**ROCKFORD BOARD OF EDUCATION
INVITATION FOR BID ON SUPPLIES, MATERIALS, EQUIPMENT OR SERVICES
FOR SCHOOL DISTRICT NO. 205
ROCKFORD, ILLINOIS**

IFB No. 22-23 HVAC & Roofing Projects at Lincoln, East, Washington & Flinn Schools

RE: **ADDENDUM NO. 9**

BASEMENT FLOOR PLAN - AREAS B & C

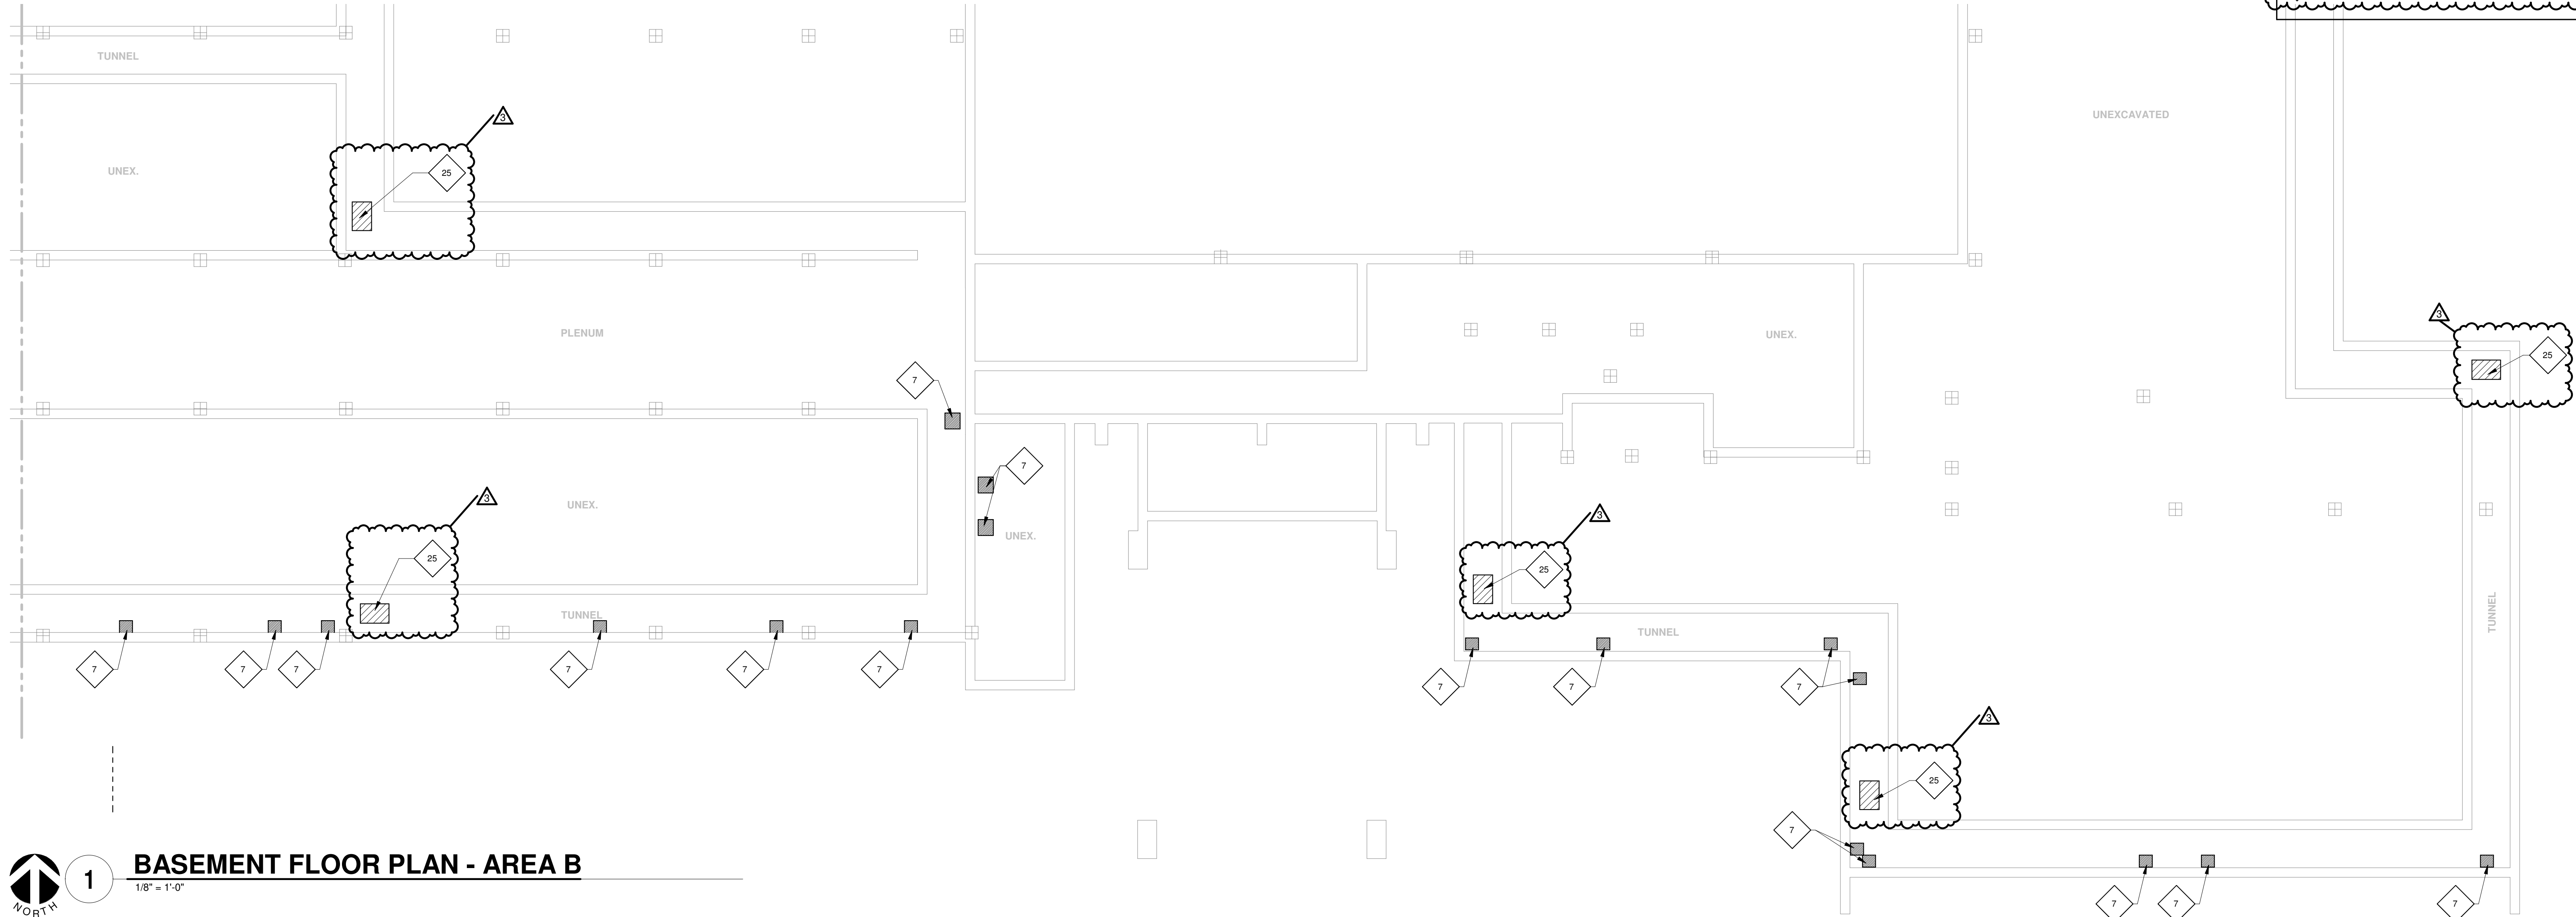
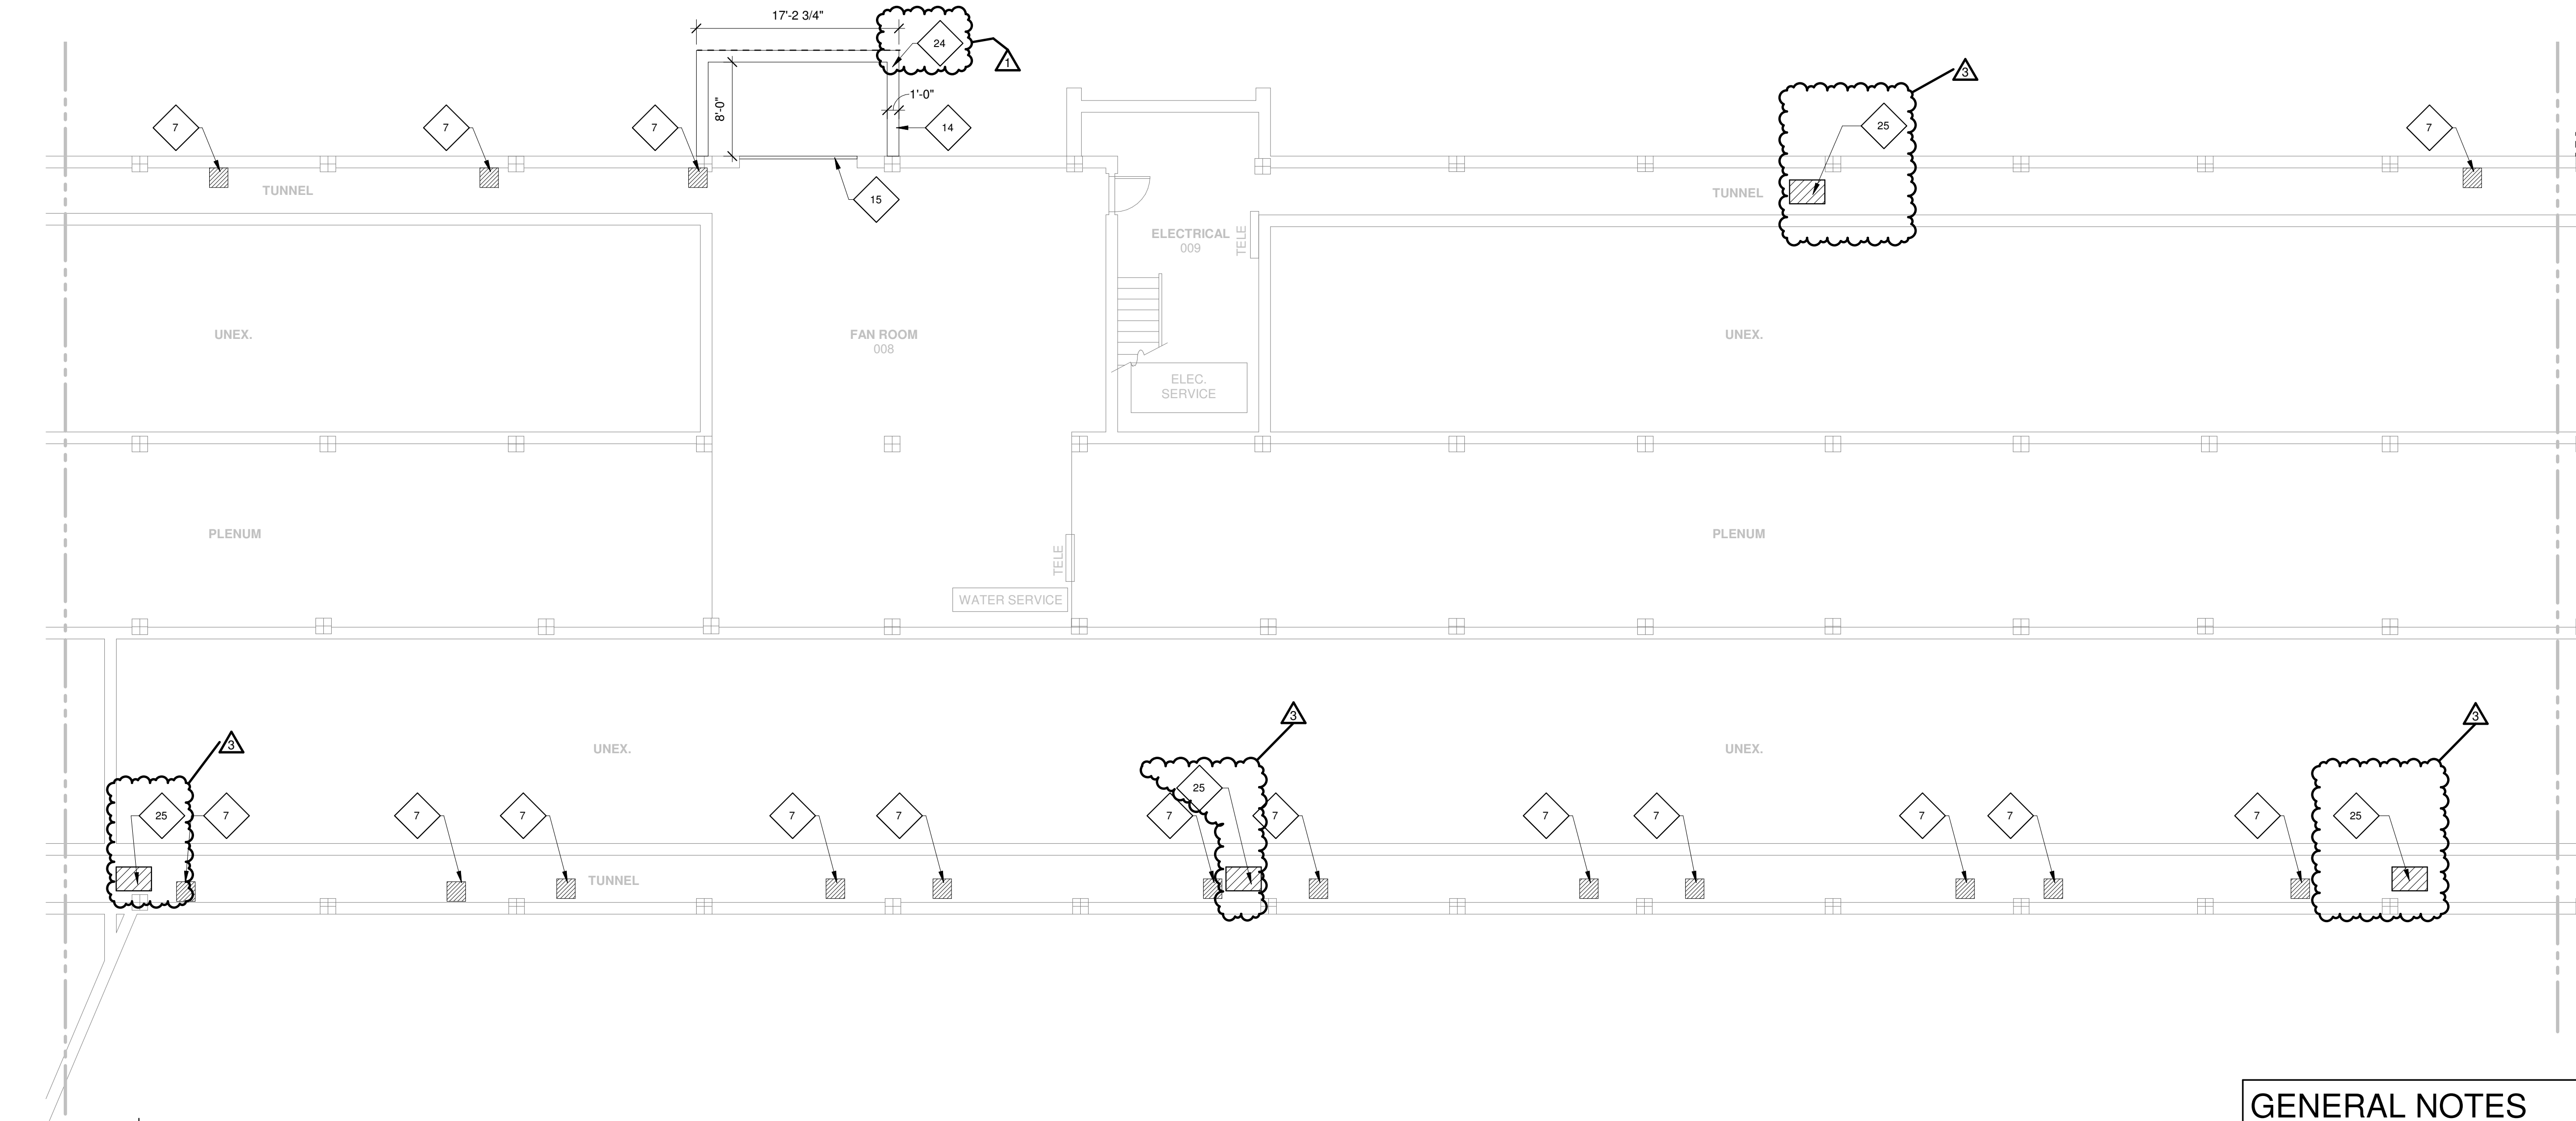
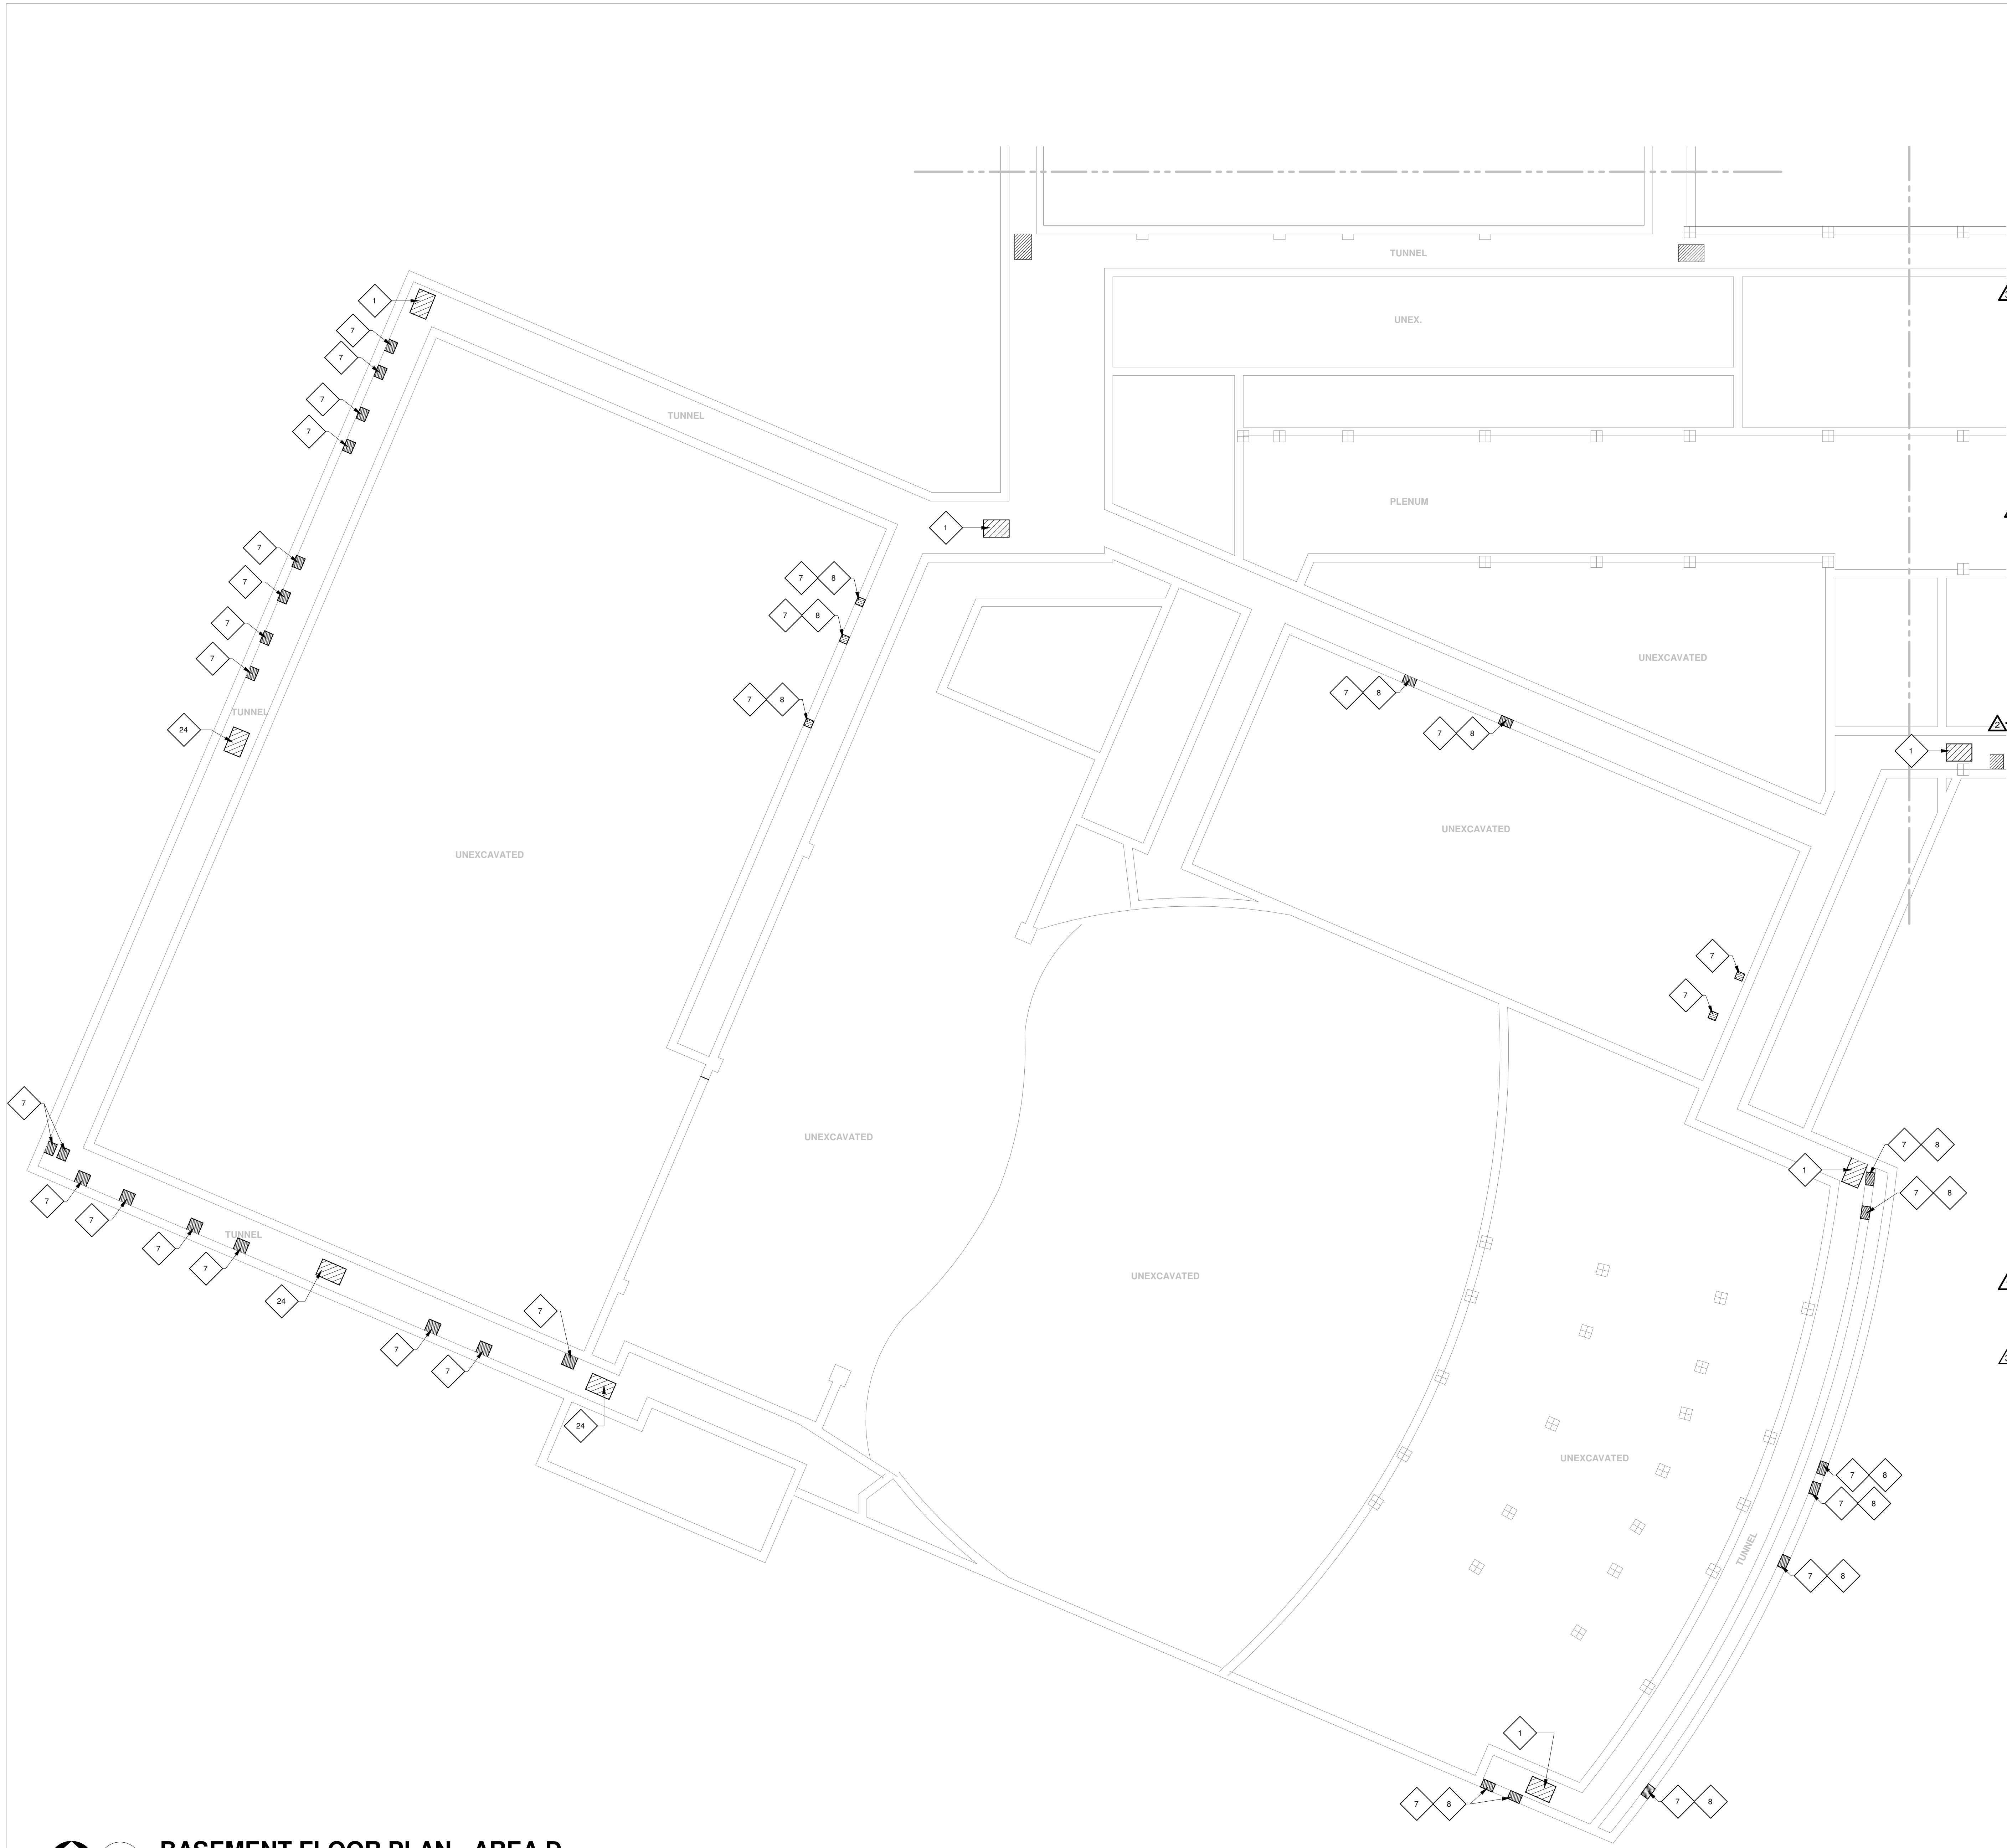
19. DRAWING A1.00B – BASEMENT FLOOR PLAN – AREA B & C **REPLACE** entire sheet with A1.00B – BASEMENT FLOOR PLAN – AREA B & C dated 03/10/2022.
 - a. **REVISE** note 1 “New 2’x3’ access door with a hinged and lockable door at the school district’s direction. Typical at all locations indicated. See detail 4/A4.00 for additional information”, to read as follows. “New 2’x3’ access door with a hinged and lockable door at the school district’s direction. Typical at all locations indicated. See detail 4A/A4.00 for additional information”.

- b. **ADD** note 25 “New 2’x3’ access door with a hinged and lockable door at the school district’s direction. Typical at all locations indicated. See detail 4B/A4.00 for additional information”.
